Chapter 4

H1: Steady, uniform flow in an open-ended channel

4.1 Problem Specification

Figure 4.2: H1 CCW-predicted solution field evolution to 600 s.

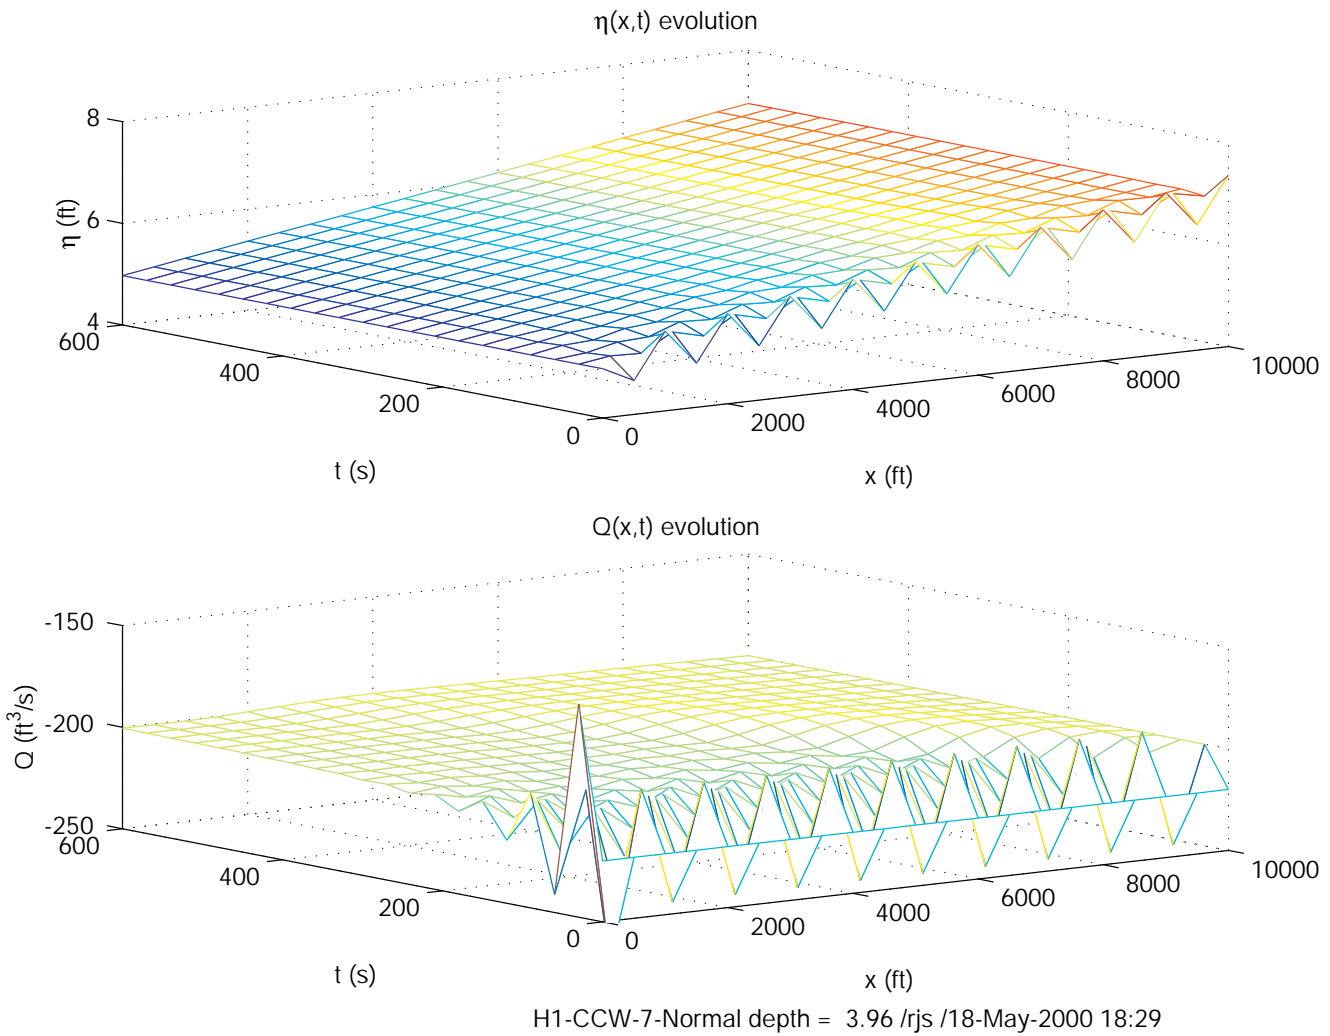
The CCW-predicted³ solution field evolution is shown in Figure 4.2. The initial conditions at $t = 0$ are close but not identical to uniform flow. Initial transients at system natural frequencies (Bode and Sobey 1984) are generated; these decay naturally with friction. This is the expected response.

With time, the system is seen to approach a steady state profile with a constant water surface slope $\partial\eta/\partial x$ and a constant Q . Again, this is the expected response.

Steady state has been approached but not been reached⁴ at $t = 600$ s. An approximation to the normal depth is the nodal-averaged water depth at this time. This is 3.96 ft. This does not correspond with the Manning value in Table 4.1 of 4.73 ft. But the CCW model is constrained to channel cross-sections that are rectangular; CCW set the rectangular width to $B = b = 23.24$ ft, for which h_n computes to 3.97 ft. Once again, this is the expected response.

³CCW re-defined the boundary condition at x_F from $Q_F = -200$ ft³/s to $\eta_F = Z_F + h_n$. This is consistent with the spirit of the problem specification.

Figure 4.3: H1 CCW-predicted conservation balances at $x = 3,000$ ft.

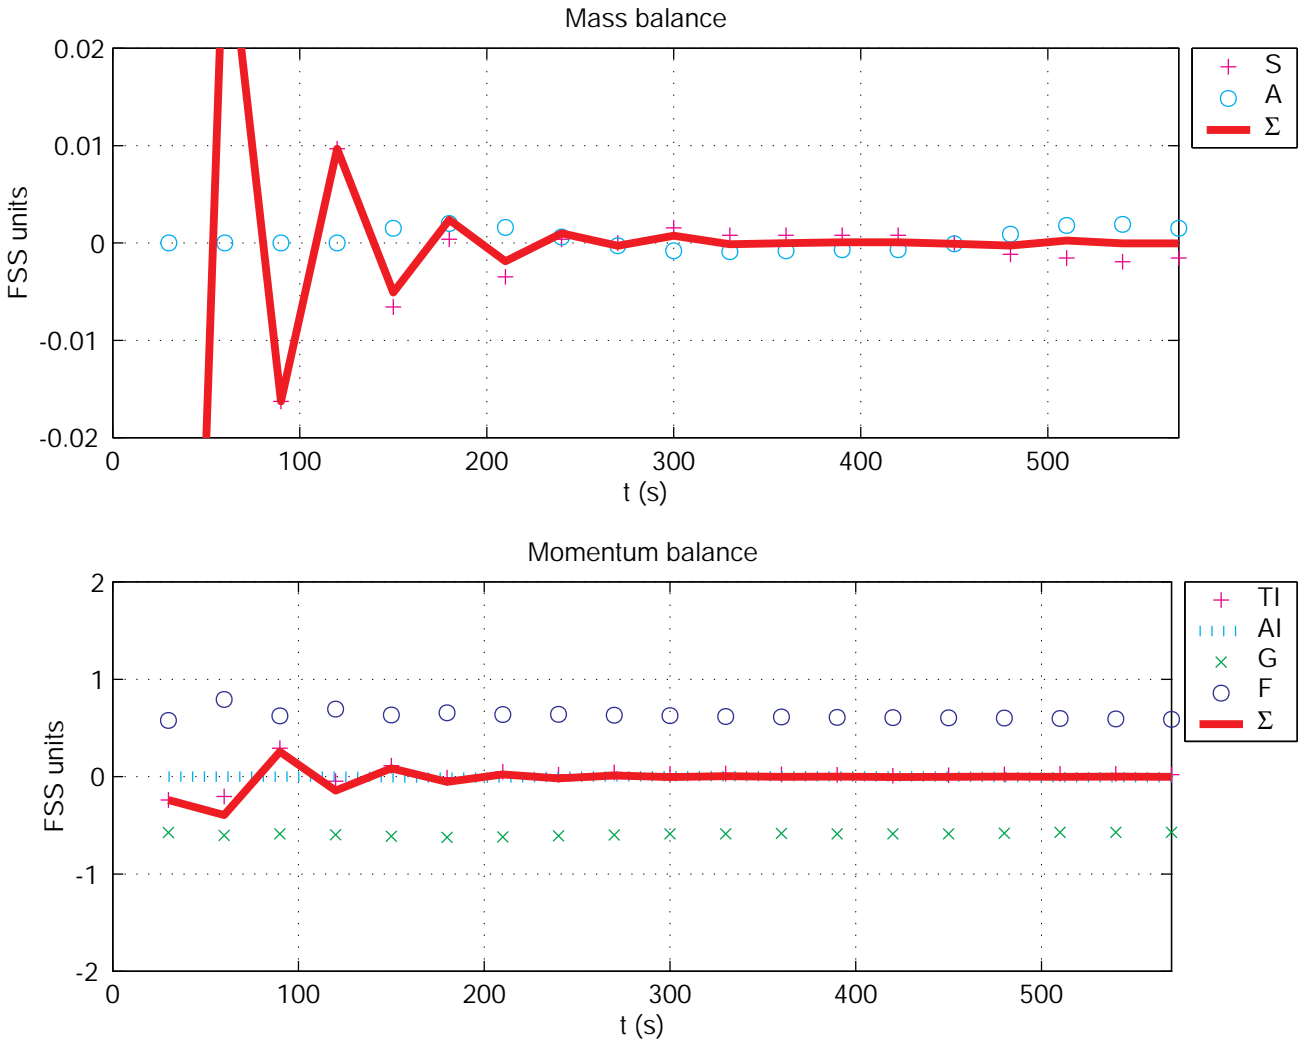
Figure 4.3 shows the time history of the mass and momentum balances⁵ at location $x = 3,000$ ft. The mass balance (the upper figure) shows each term in Equation 2.4.1; in the legend, S is storage, A is advection and $\Sigma = S + A$ is the mass balance, which should be identically zero. The model does not in fact conserve mass for $t < 200$ s. At these times, the solution evolution is dominated by the rapid initial transients that are poorly resolved by the adopted space scale ($\Delta x = 500$ ft) and time scale ($\Delta s = 30$ s). At later times, when the response is not resolution-challenged, mass is clearly conserved. This is the expected response.

The momentum balance (the lower figure) show each term in Equation 2.4.2; in the legend, TI is temporal inertia, AI is advective inertia, G is gravity and F is friction. Again, $\Sigma = TI + AI - G - F$ is the momentum balance, which should be identically zero. After the initial transients, momentum is clearly conserved. Also shown is the dominant gravity = friction ($G = F$) balance at uniform flow.

Figure 4.4: H1 DWR-predicted solution field evolution to 600 s.

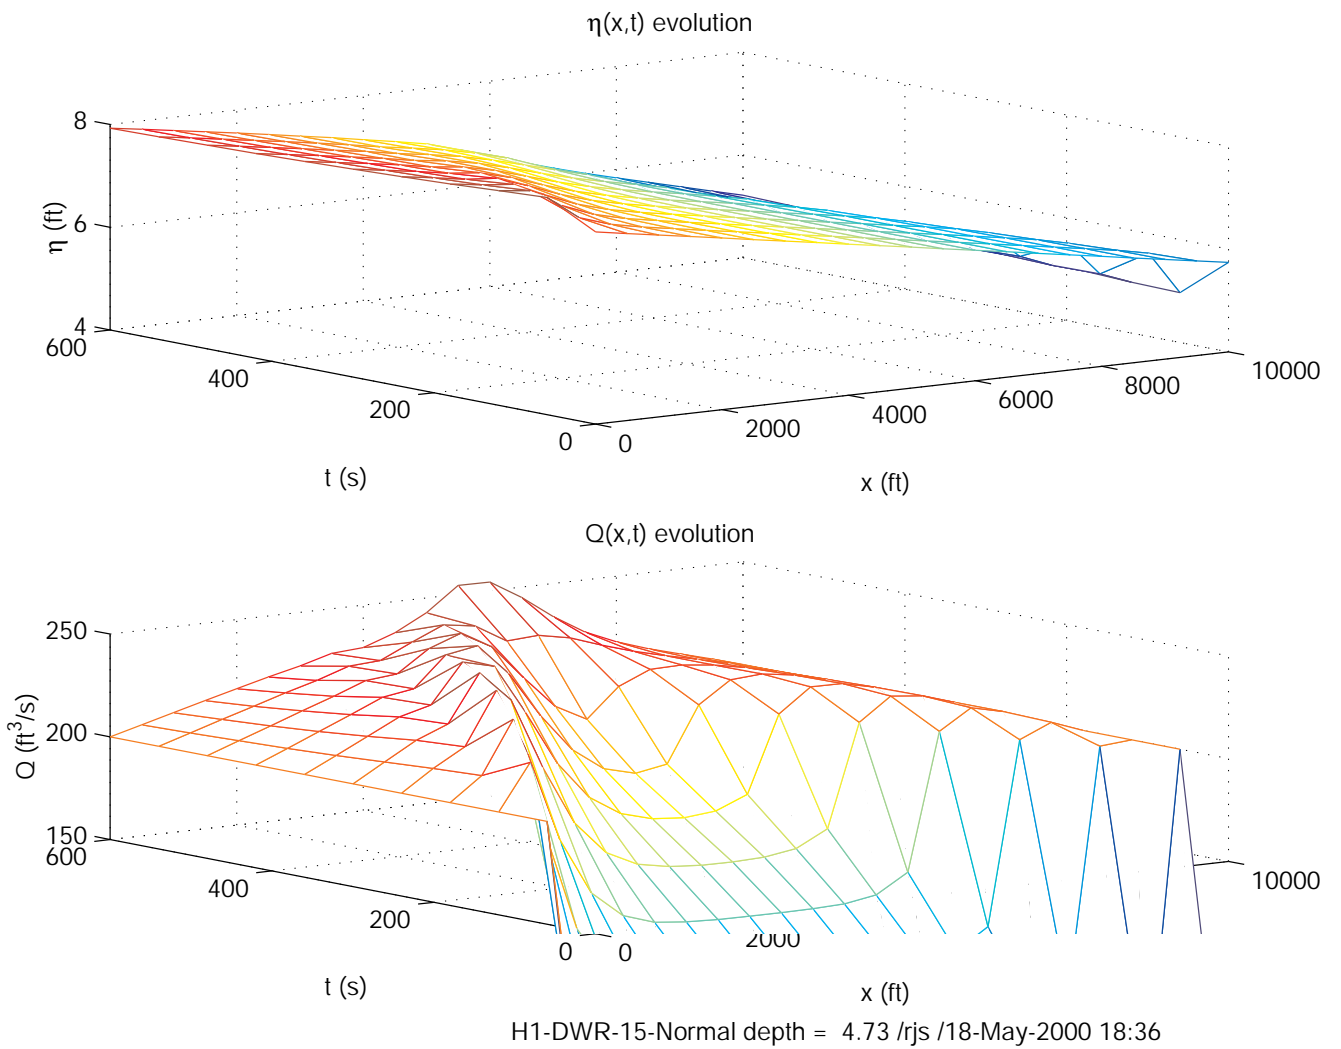
The DWR-predicted⁶ solution field evolution is shown in Figure 4.4. The initial conditions at $t = 0$ for water level $\eta(x, 0)$ are close but not identical to uniform flow. The initial conditions for flow $Q(x, 0)$ are zero, so that there must be a very significant transition to uniform flow at a steady and uniform 200 ft³/s. Such a large change is well within the predictive capabilities of the field equations, as is indeed demonstrated in this case. The steady state has clearly not been approached at $t = 600$ s.

⁶A recurring difficulty with the DWR responses has been frequent re-definition of the test problems to accommodate apparent inflexibility in their code. The spatial coordinate x has been directed downstream and not upstream. Equally confusing has been a data file error in reporting the computational time step Δt . Δt is consistently reported in the data files as 1 s; it was apparently not the specified 30 s, but 60 s. Other changes vary with the problem.

Figure 4.5: H1 DWR-predicted solution field evolution to 1500 s.

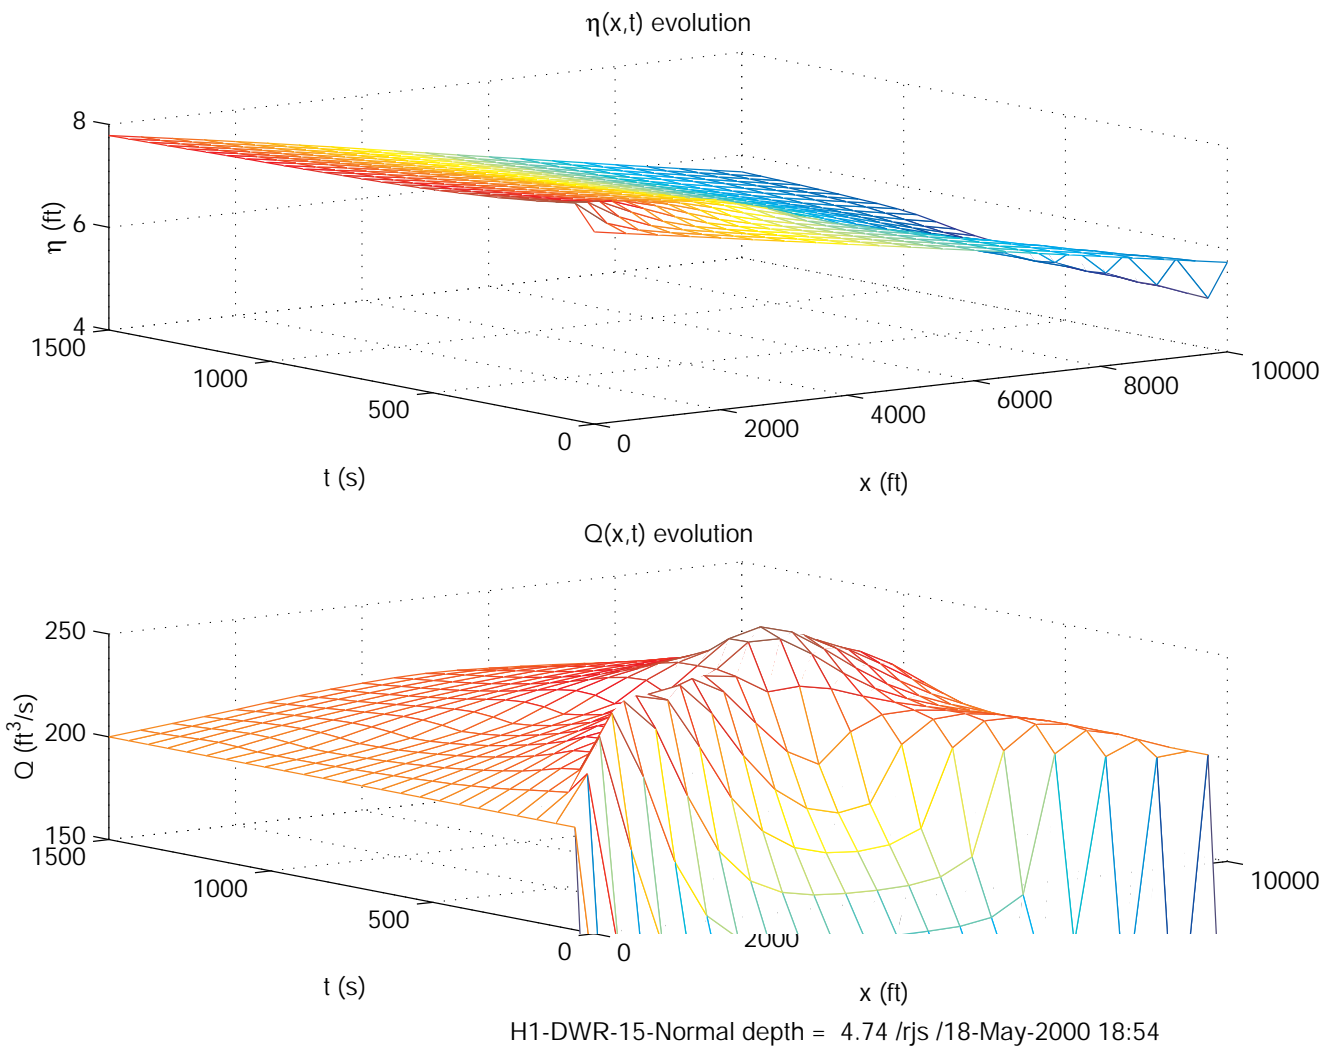
Initial transients at system natural frequencies are generated (Bode and Sobey 1984); these decay naturally with friction. This is the expected response, and is well illustrated in Figure 4.5 where the predicted evolution has been extended to $t = 1500$ s. With time, the system is seen to approach a steady state profile with a constant water surface slope $\partial\eta/\partial x$ and a constant Q .

Steady state has been approached but not been reached at $t = 1500$ s. An approximation to the normal depth is the nodal-averaged water depth at this time. This is 4.74 ft, which corresponds almost exactly with the Manning value in Table 4.1; it does correspond exactly on further extension. Once again, this is the expected response.

Figure 4.6: H1 DWR-predicted conservation balances to 600 s at $x = 7,000$ ft.

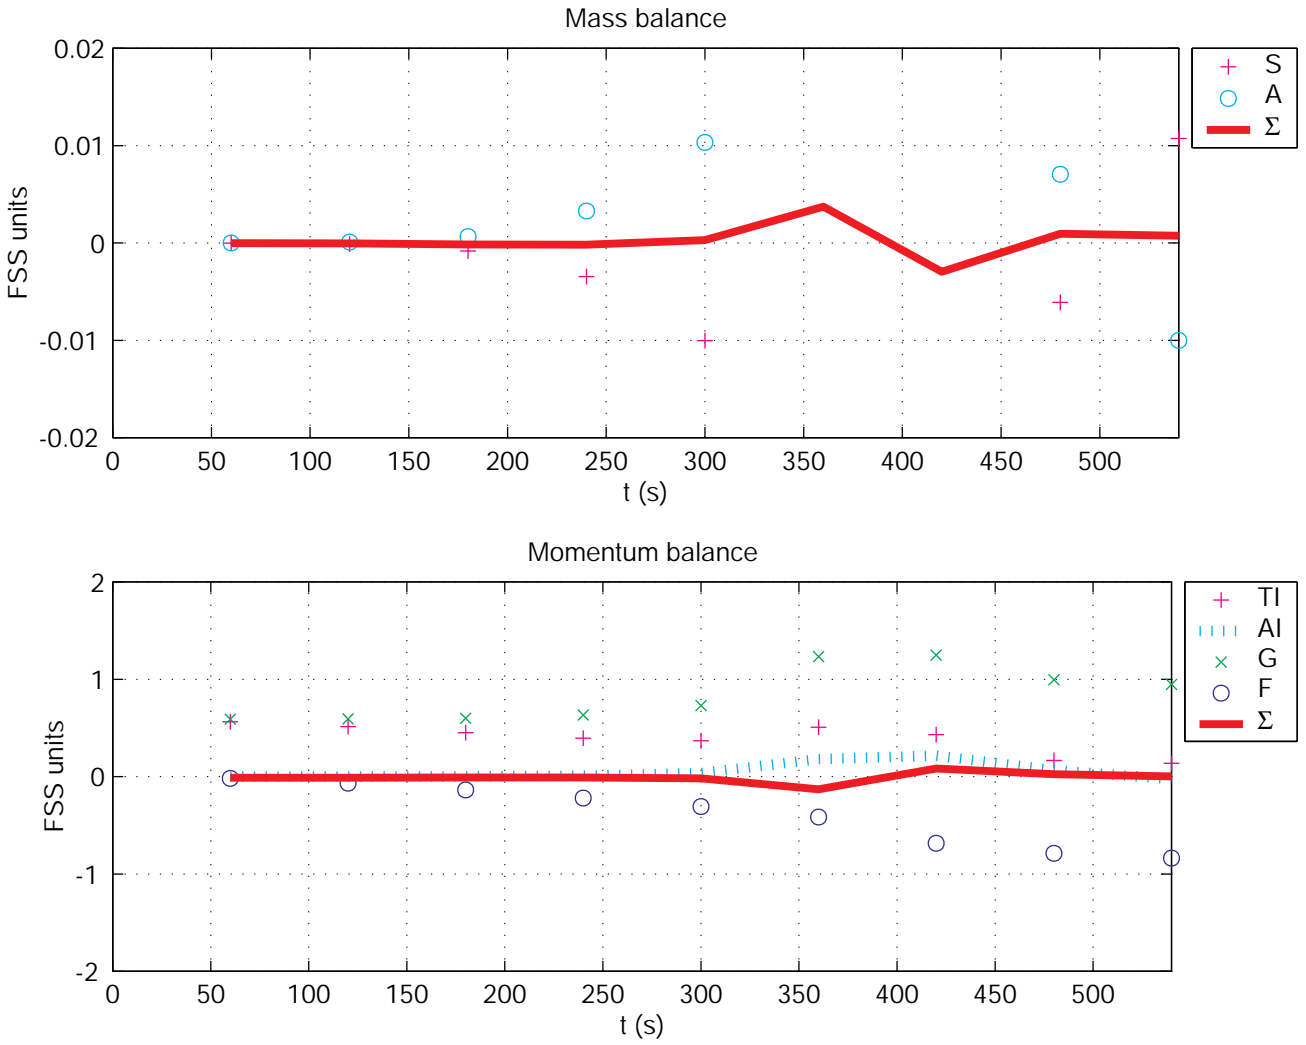
Figure 4.6 shows the time history of the mass and momentum balances at location $x = 7,000$ ft. The mass balance (the upper figure) shows each term in Equation 2.4.1; in the legend, S is storage, A is advection and $\Sigma = S + A$ is the mass balance, which should be identically zero. The model does not in fact conserve mass in the region around $t = 400$ s. At these times, the solution evolution is dominated by the rapid initial transients that are poorly resolved by the adopted space scale ($\Delta x = 500$ ft) and time scale ($\Delta s = 60$ s). At later times, when the response is not resolution-challenged, mass is clearly conserved; see Figure 4.7. This is the expected response.

The momentum balance (the lower figure) shows each term in Equation 2.4.2; in the legend, TI is temporal inertia, AI is advective inertia, G is gravity and F is friction. Again, $\Sigma = TI + AI - G - F$ is the momentum balance, which should be identically zero. After the initial transients, momentum is clearly conserved. Also shown is the dominant gravity = friction ($G = F$) balance at uniform flow.

Figure 4.8: H1 RMA-predicted solution field evolution to 600 s.

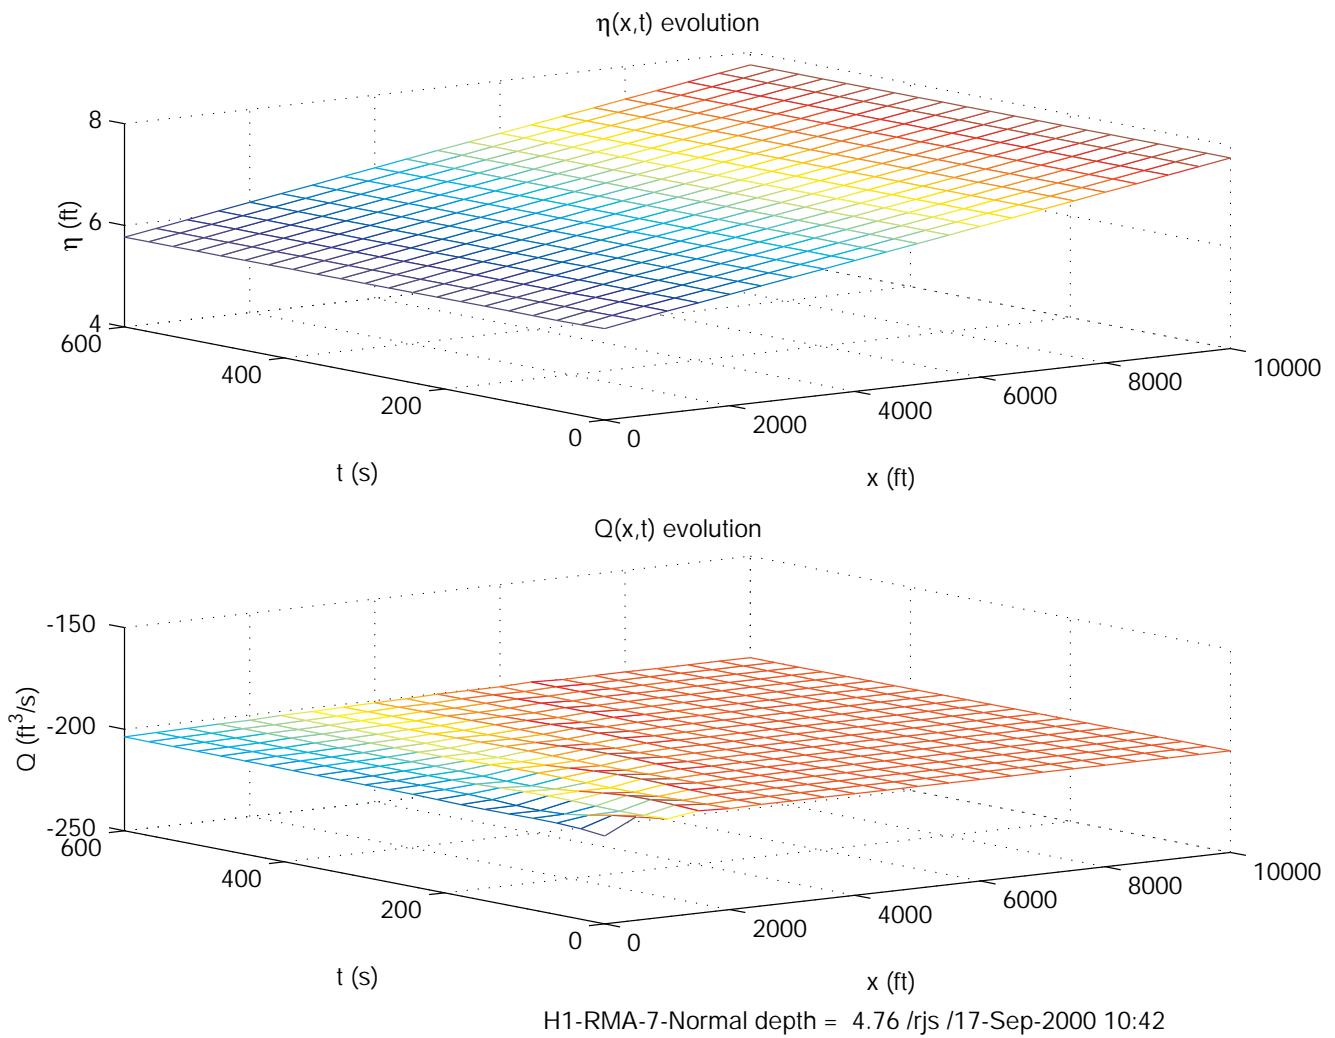
The RMA-predicted⁷ solution field evolution is shown in Figure 4.8. The initial conditions at $t = 0$ are very close and almost identical to uniform flow. Some initial transient activity is apparent in the Q evolution; these decay naturally with friction. This is the expected response.

With time, the system is seen to approach a steady state profile with a constant water surface slope $\partial\eta/\partial x$ and a constant Q . Again, this is the expected response.

The steady state seems to have been approached but not completely reached at $t = 600$ s. An approximation to the normal depth is the nodal-averaged water depth at this time. This is 4.76 ft. This does not correspond exactly with the Manning value in Table 4.1 of 4.73 ft. Predictions to $t = 29,970$ s are provided. These are visually at uniform flow. Q is steady at -200.0 ft³/s, but the steady depth (predicted by the “stage-elevation relation”) at x_F is 4.7219 ft, whereas the steady depth (predicted by the code) at x_L is 4.7374 ft. This is not uniform flow, but a classical M_2 steady, gradually-varied flow profile.

While this is not uniform flow, it is quite close to uniform flow and there is no suggestion that this is not an expected and appropriate result. There seems to be a small inconsistency between uniform flow at 200 ft³/s estimated from the code (at x_L) and from the “stage-elevation relation”) at x_F .

⁷RMA re-defined the boundary condition at x_F from $Q_F = -200$ ft³/s to $\eta_F(t) = Z_F + \tilde{h}_n(t)$, where $\tilde{h}_n(t)$ is defined by a “stage-elevation relation”. In principle, this is consistent with the spirit of the problem specification.
